## CITY OF GLENDALE, CA

### DESIGN REVIEW STAFF REPORT – COMMERCIAL / INDUSTRIAL / MIXED USE

<b>April 14, 2025</b> <i>Decision Date</i>	<b>712, 714 and 716 Ivy Street</b> <i>Address</i>
<b>Administrative Design Review (ADR)</b> <i>Review Type</i>	<b>5695-009-005 and 5695-009-006</b> <i>APN</i>
<b>PADR-003896-2024</b> <i>Case Number</i>	<b>Alex Albarian</b> <i>Applicant</i>
<b>Columba Diaz</b> <i>Case Planner</i>	<b>Alex Albarian</b> <i>Owner</i>

To construct a new two-story, approximately 4,580 square-foot detached commercial building (warehouse) at the rear of an existing 3,046 square-foot one-story commercial building (warehouse and dental office), located on two adjoining lots, totaling 14,557 square feet, zoned IMU (Industrial/Commercial Mixed Use). The project includes 18 new surface parking spaces.

PROPOSED SITE PLAN

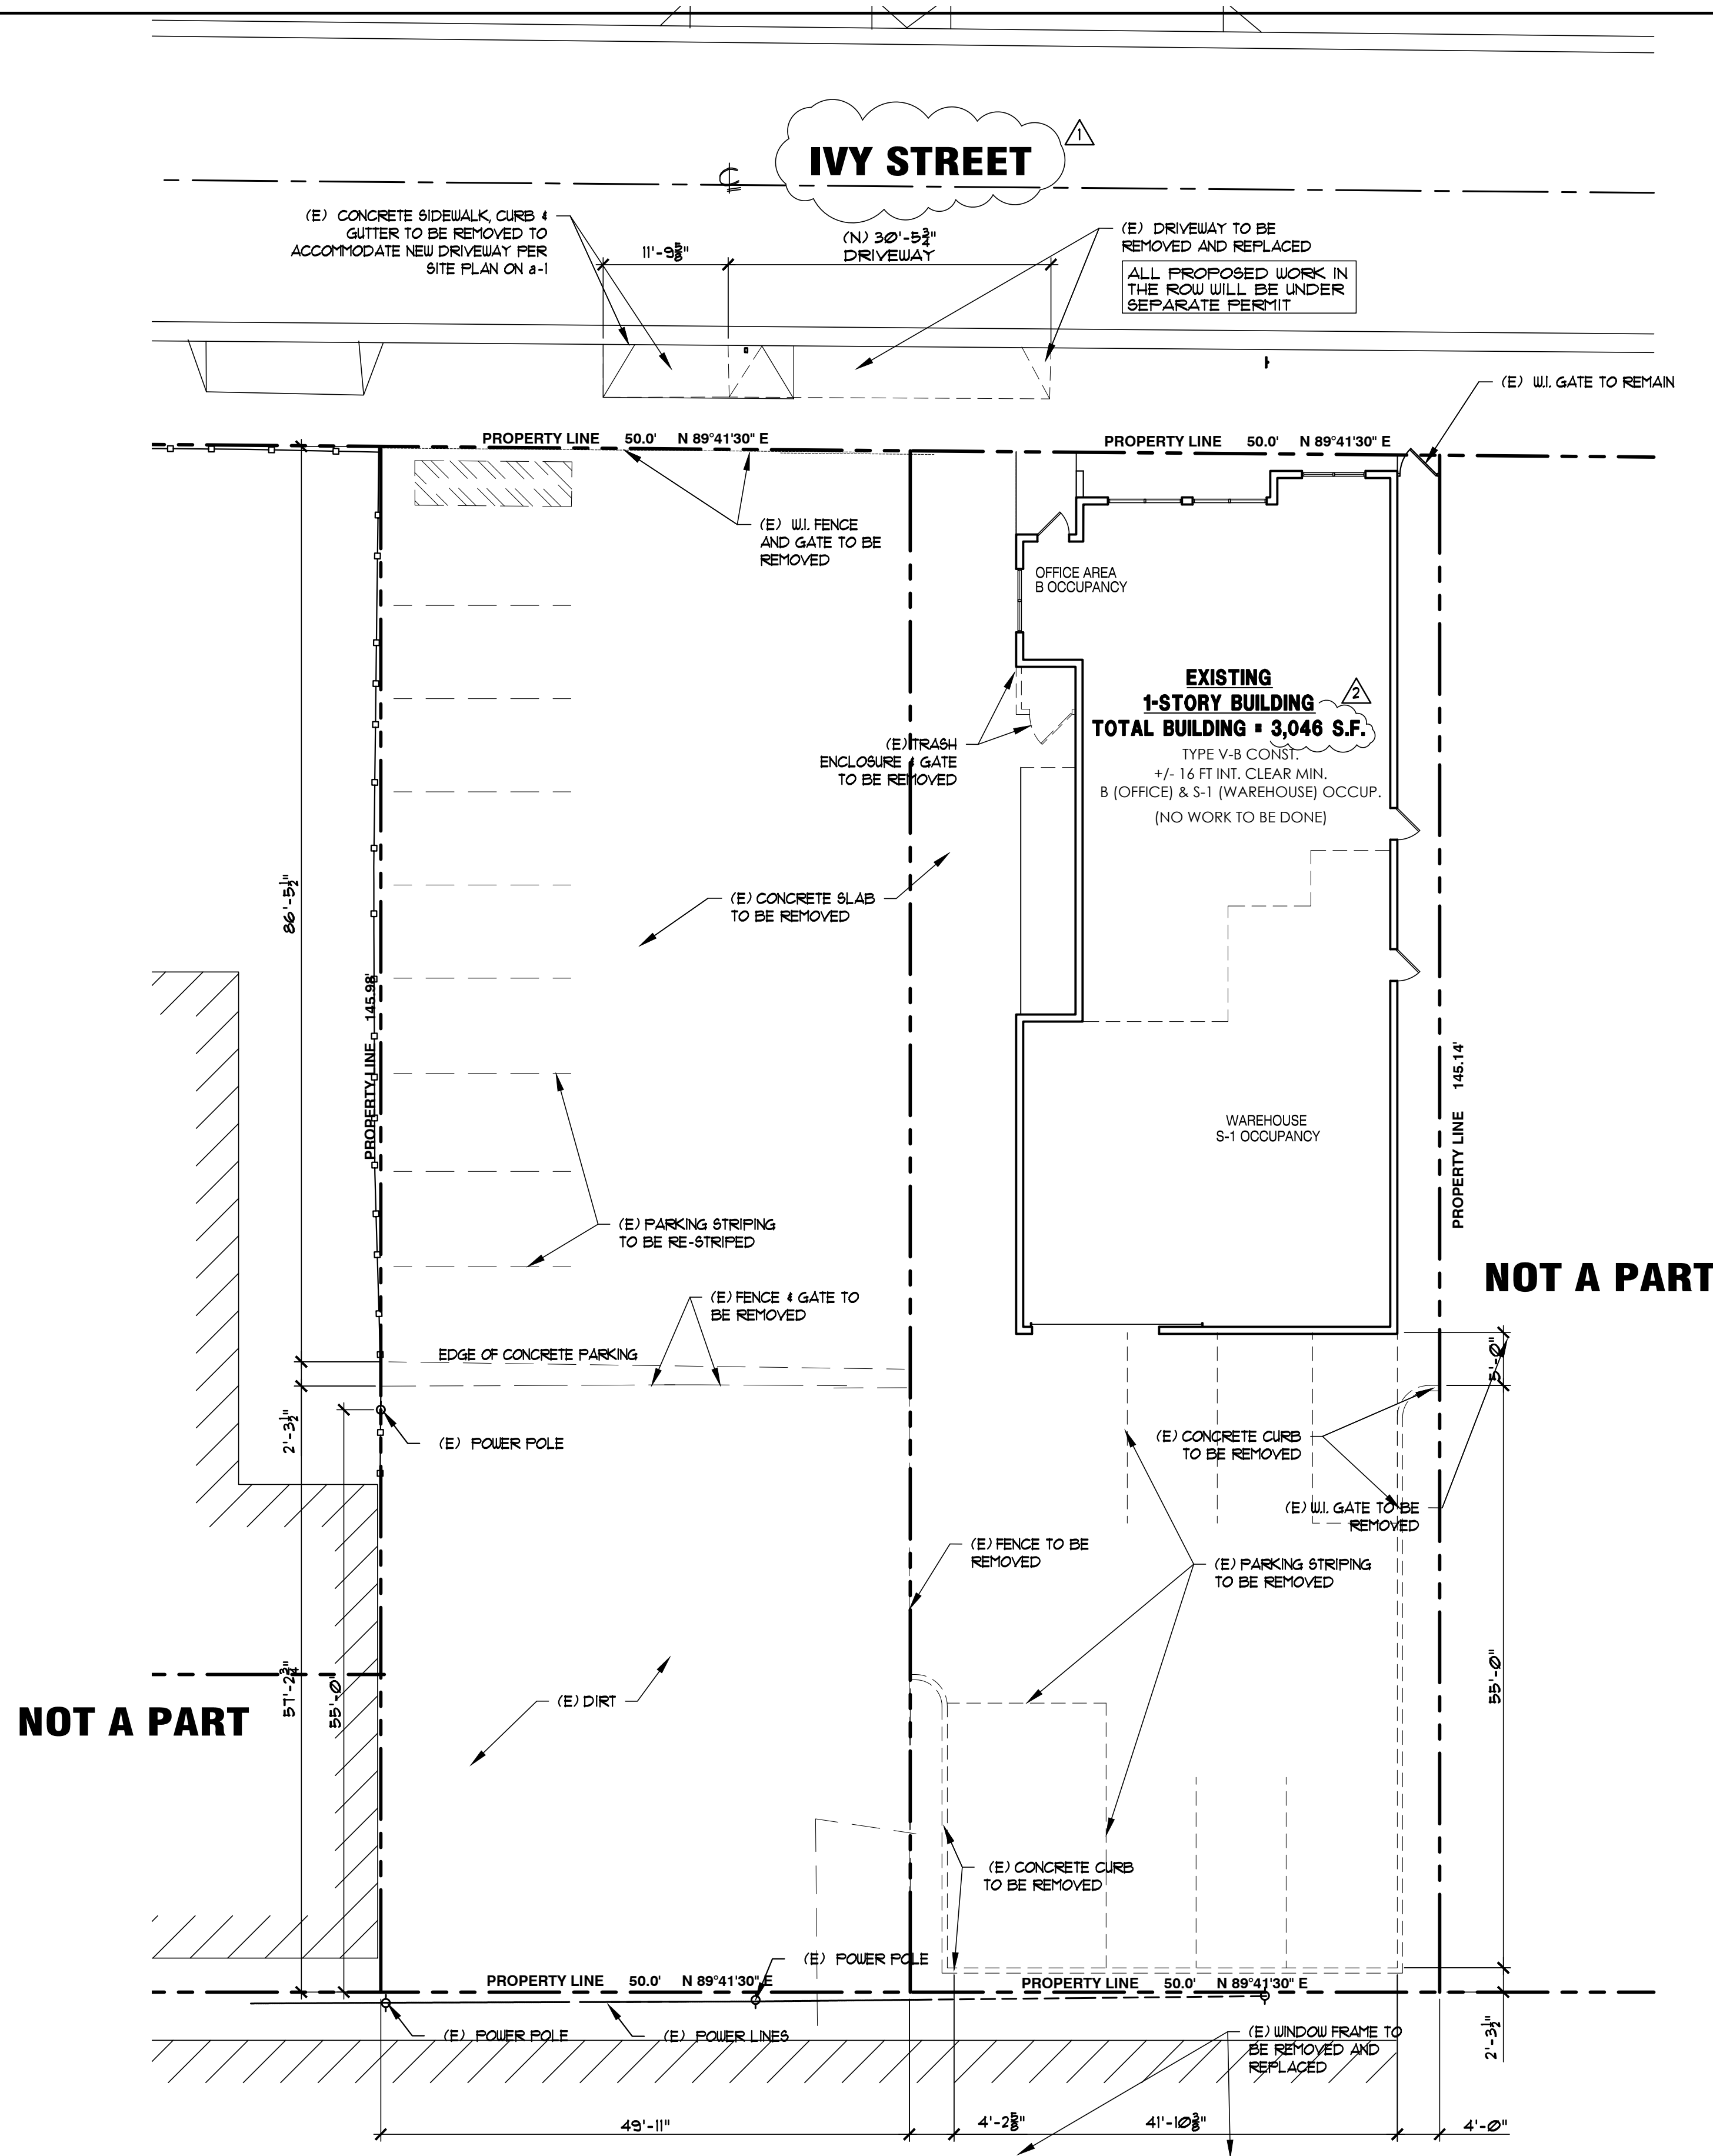
The proposed parking lot restriping will replace the existing concrete slabs and surface parking spaces. A condition of approval is added to update the design to include decorative or colored paving materials at building entries to delineate pedestrian areas.

The project is proposing street-facing fences and gates. A condition of approval is added to provide the design and materials for the proposed fence and gates to be appropriate to the overall design concept and that they be set back behind landscaped areas to help minimize the visual impact.

building and the loading zone is located at the rear of the site, partially behind the existing building. The parking design and location are appropriate to the site and its neighborhood context. However, a condition of approval is added to update the design to include decorative or colored paving materials at building entries to delineate pedestrian areas.

- The project is proposing street-facing fences and gates. A condition of approval is added to provide the design and materials for the proposed fence and gates to be appropriate to the overall design concept and that they be set back behind landscaped areas to help minimize the visual impact.

1. Update plans to include the required street trees per Public Works – Urban Forestry requirements and obtain the required permits for the installation of two new street trees.
2. Update the site plan and landscape plan to clearly show the required two (2) street trees.
3. Provide the design and materials for the proposed fence and gates (street facing) to be appropriate to the overall design concept.
4. Update plans to set back the street facing fences and gates to locate behind the landscaped areas to help minimize the visual impact.
5. Update the design to include decorative or colored paving materials at building entries to delineate pedestrian areas.

## PRELIMINARY LANDSCAPE PLAN

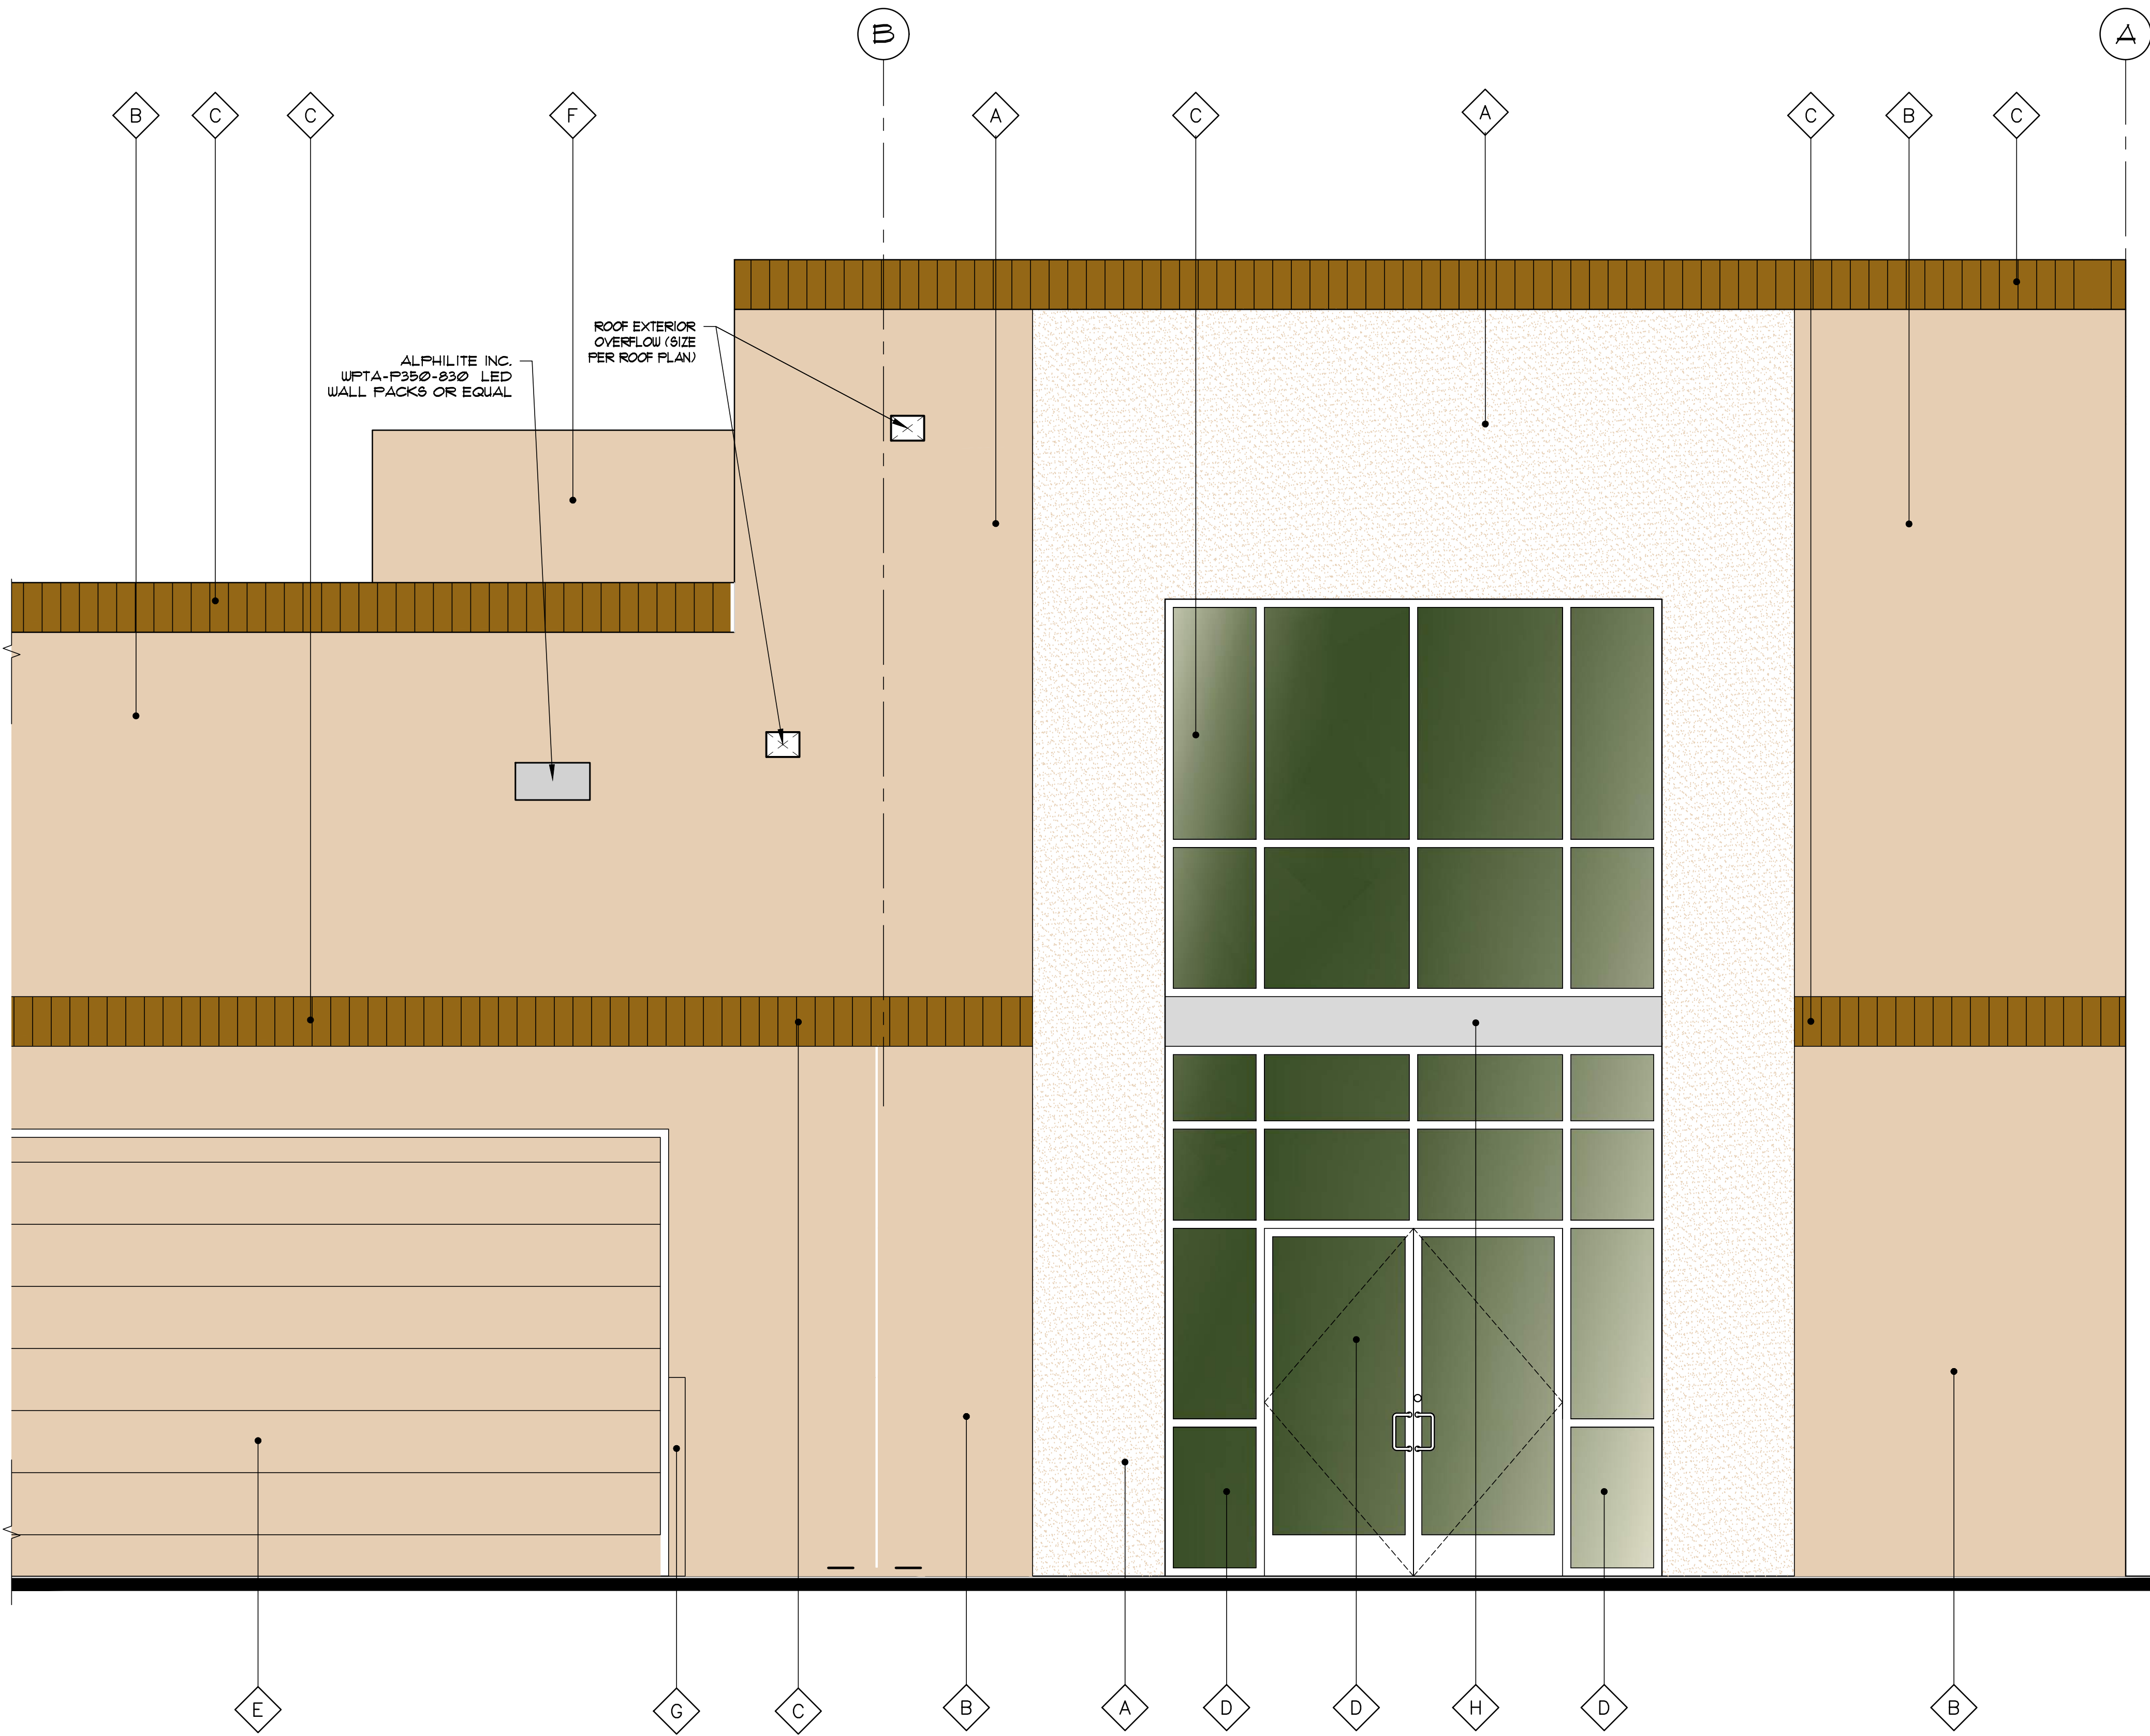
The proposed trees and shrubs are adequately located adjacent to the sidewalk, appropriately screening the street front surface parking lot. A condition of approval is added to update plans to include the required street trees per Public Works – Urban Forestry requirements and obtain the required permits for the installation of two new street trees. The proposed site plan and landscape plan shall be updated to clearly show the required two (2) street trees.

- The proposed trees and shrubs are adequately located adjacent to the sidewalk, appropriately screening the street front surface parking lot. A condition of approval is added to update plans to include the required street trees per Public Works – Urban Forestry requirements and obtain the required permits for the installation of two new street trees. The proposed site plan and landscape plan shall be updated to clearly show the required two (2) street trees.
